**Re: Response to Oregon Department of Environmental Quality’s Review  
Kinder Morgan Seismic Vulnerability Assessment  
Willbridge Terminal  
Portland, Oregon**

Table 1  
Kinder Morgan Willbridge Terminal

Ic Cumulative Frequency Willbridge

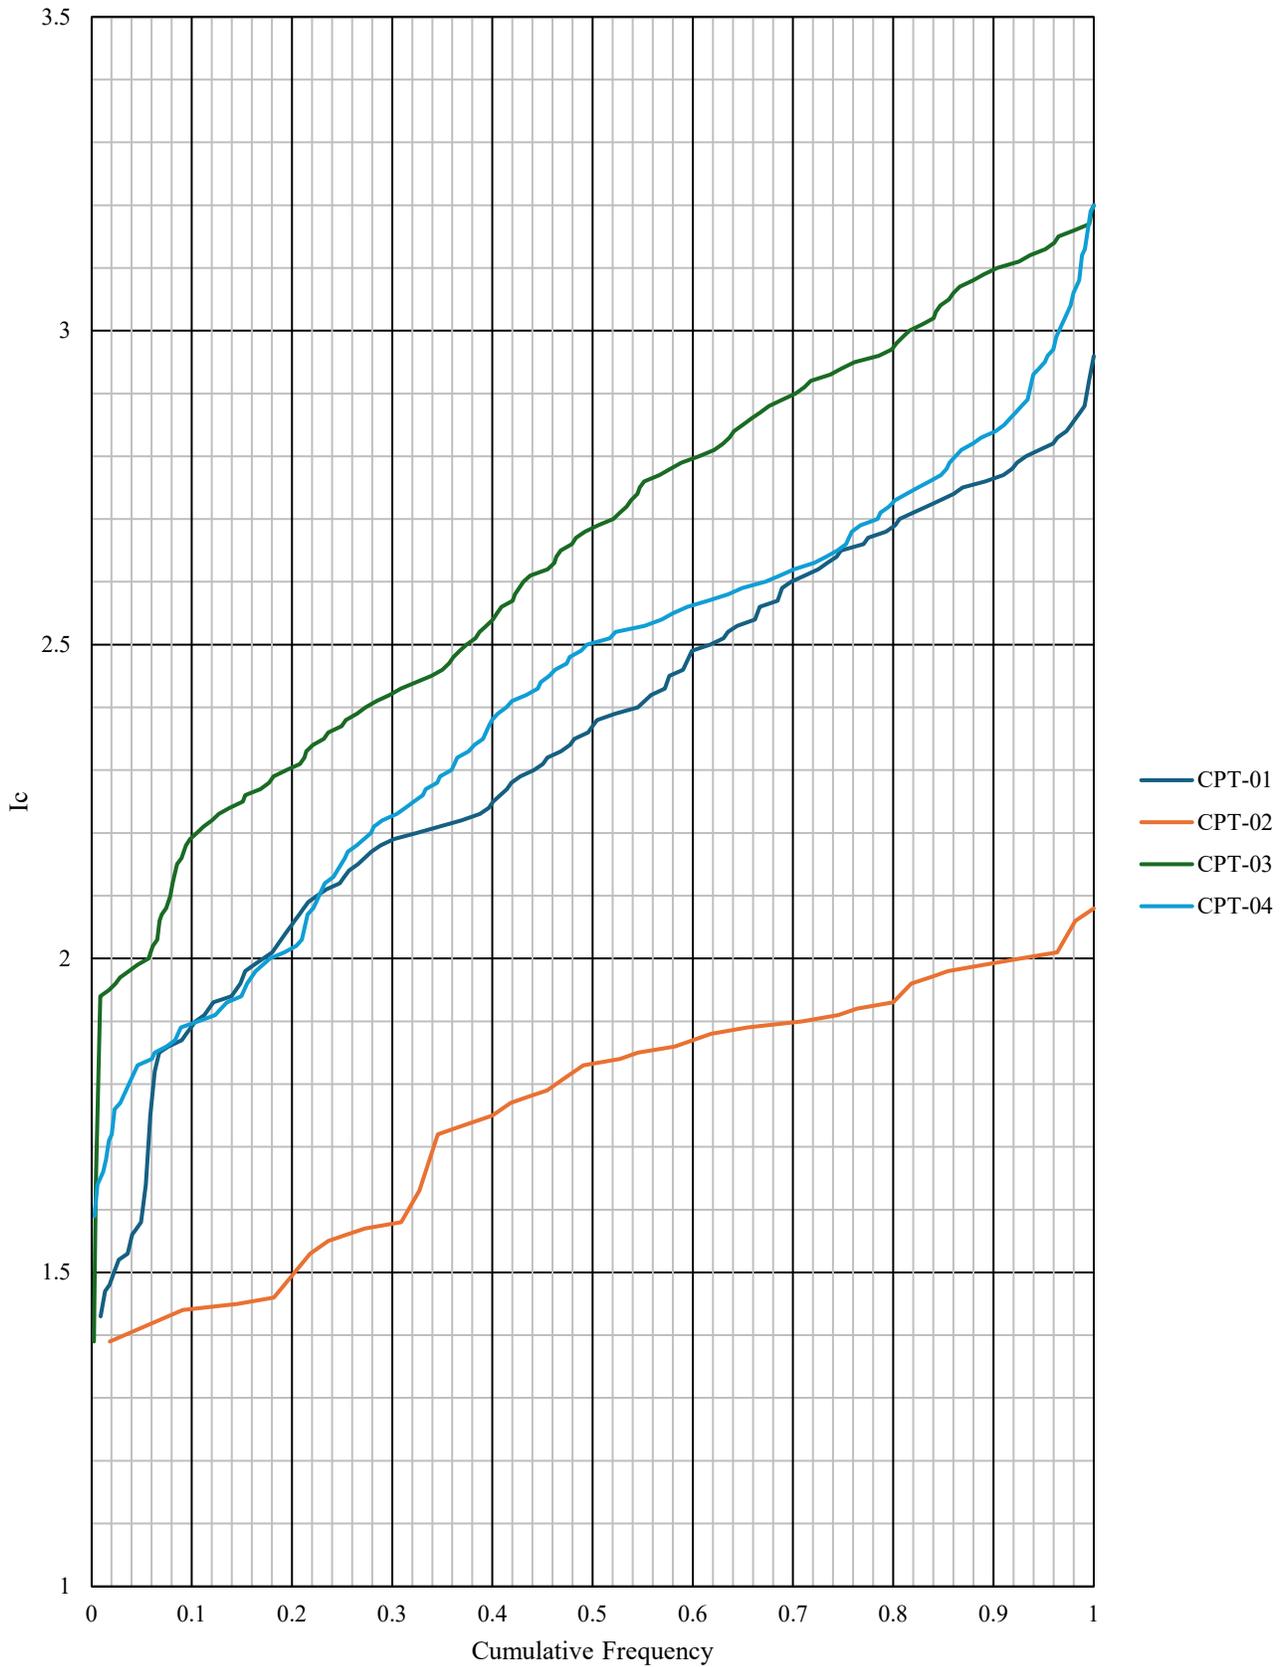
5a	<p>Liquefaction potential in "Sand-Like" Soil and Cyclic Degradation in "Clay-Like" Soil How was cyclic resistance ratio evaluated (simplified or site-specific)? [GEO5]</p>	<p>Simplified. This is addressed in great detail in SVA section 5.1.1.2.2 and Appendix A-3. Supplemental information is provided below:</p> <p>The average <math>S_{u,r}</math> discussed in SVA section 5.1.1.2.2 was computed based on liquefaction FS with a FS cutoff of 1.0 (see comment/response to question 5f for additional discussion on using FS=1.0). This means that all soil layers with FS&lt;1.0 were assigned a residual shear strength based on their CRR (i.e., the sand-like approach), regardless of their <math>I_c</math>. In other words, layers that are clay-like and may only degrade 85 percent or so of their static strength were still assigned a sand-like residual shear strength if they were triggered (i.e., FS &lt;1.0). This is a conservative approximation/simplification.</p> <p>As discussed in section 5.1.1.2.2, CPT soil behavior type <math>I_c</math> was used to determine susceptibility to liquefaction. Specifically, we selected <math>I_c &gt; 3.0</math> as not susceptible to liquefaction. Triggering calculations are performed on all soil layers (i.e., the liquefaction FS is computed for all soil layers) and is not automatically set larger than 2 if not susceptible. Typically, an <math>I_c</math> of 2.6 is used to determine susceptibility (i.e. <math>I_c &lt; 2.6</math> is not susceptible per Robertson and Wride 1998). Our experience with Willamette Silts/Willamette River Alluvium from several sites along NW St. Helens Blvd and Yeon Ave indicates that an <math>I_c</math> of 2.6 is typically an unconservative cutoff. However, we have not observed a strong correlation between plasticity index and <math>I_c</math> for these soils. Therefore, we have selected <math>I_c</math> of 3.0 as the cutoff based on the following justification. First, it represents a more fines-dominant soil behavior type grouping. Second, by using <math>I_c &gt; 3.0</math> as the susceptibility cutoff, we filter out all data with a normalized friction ratio F less than about 2 percent, indicating low likelihood of liquefaction because F is large (Robertson and Wride 1998). Finally, as shown by the cumulative frequency of <math>I_c</math>, using <math>I_c</math> of 3.0 excludes about 0 to 18 percent of data from being susceptible to liquefaction. These three points indicate a conservative approach to determining susceptibility and sand-like vs. clay-like behavior. Our opinion is that this approach is suitable for a vulnerability assessment.</p>

Liquefaction FS Cumulative Frequency Willbridge

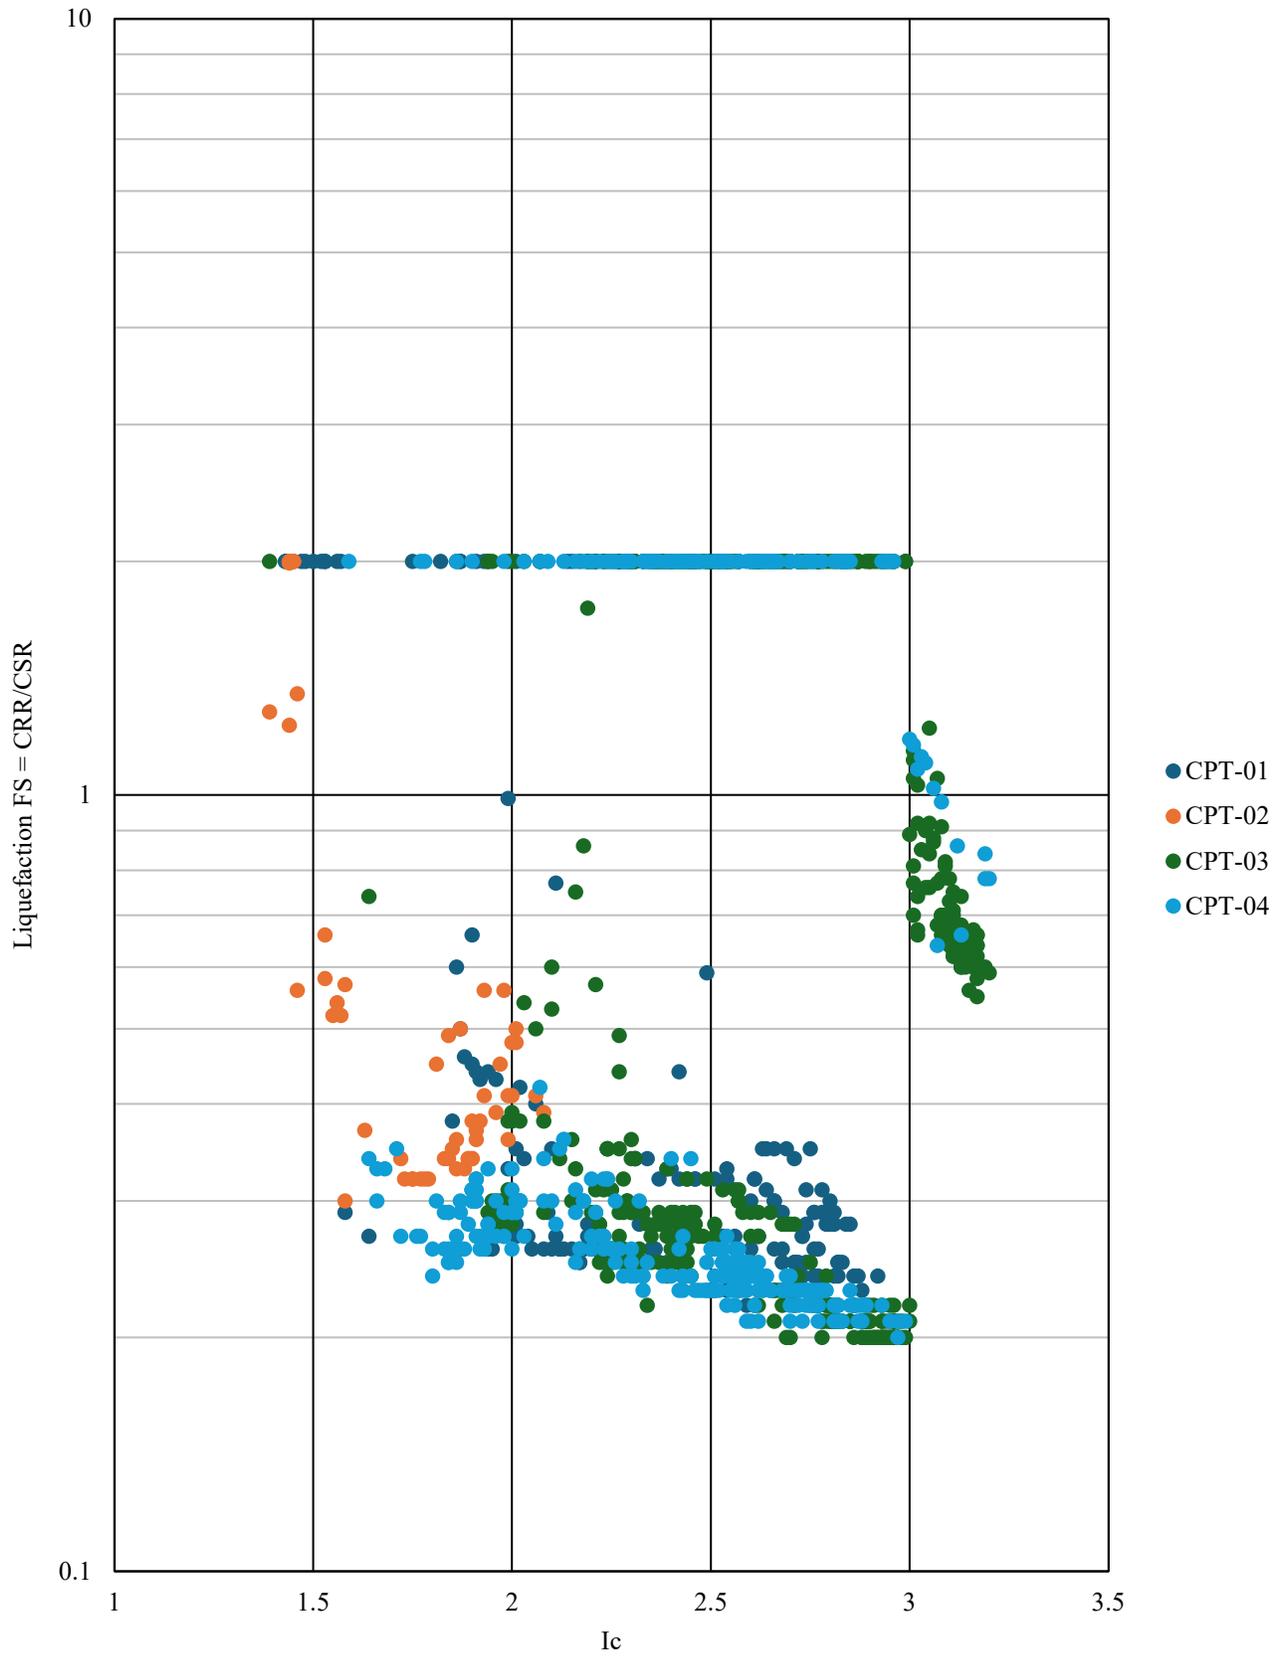
5d	What methodology was used to calculate residual shear strength? [GEO5]	See SVA section 5.1.1.2.2.
5e	What safety factor for liquefaction in sand (CRR/CSR). [GEO5]	Not sure what is the question here? A safety factor of 1.0 was used to distinguish between triggered and not triggered susceptible soils.
5f	If using a simplified procedure, what current methodology has been used? Is the safety factor less than 1.4, what reduction factor has been applied to the initial shear strength of the soil? [GEO5]	<p>See SVA Section 5.1.1.2.2. As noted above, a safety factor of 1.0 was used to create a simple binary condition of either fully liquefied or non-liquefied and no distinction was made for "partially liquefied" soil. This approach was selected for simplicity and is suitable for the vulnerability assessment.</p> <p>Attachment 1 provides additional analysis of the CPT data. Consider the plot of soil behavior type (represented with <math>I_c</math>) versus Liquefaction FS. The software program Cliq was used to complete liquefaction calculations. As shown with this plot by the data points with <math>I_c &gt; 3.0</math> (our susceptibility threshold - discussed previously on comment/response no. 5a) and <math>FS &lt; 1.0</math>, Cliq completes triggering calculations (i.e., Liquefaction FS) regardless of whether a soil is susceptible (i.e., whether <math>I_c</math> is <math>&gt; 3.0</math>). This plot demonstrates that in our calculations, the quantity of data points triggered (i.e. liquefaction FS ) and specifically <math>FS &gt; 1.4</math>, is not artificially inflated due to susceptibility or non-susceptibility.</p> <p>Attachment 1 also shows cumulative frequency plots of liquefaction FS. As shown by the cumulative frequency, between approximately 1 and 6 percent of all individual CPT measurements resulted in a computed FS between 1.0 and 1.4. This corresponds to approximately 2 ft or less of soil that is in a "partially liquefied" liquefied state.</p> <p>These plots demonstrate that distinguishing a partially liquefied state for this site is not significant, especially for a study intended to determine general seismic vulnerability.</p>
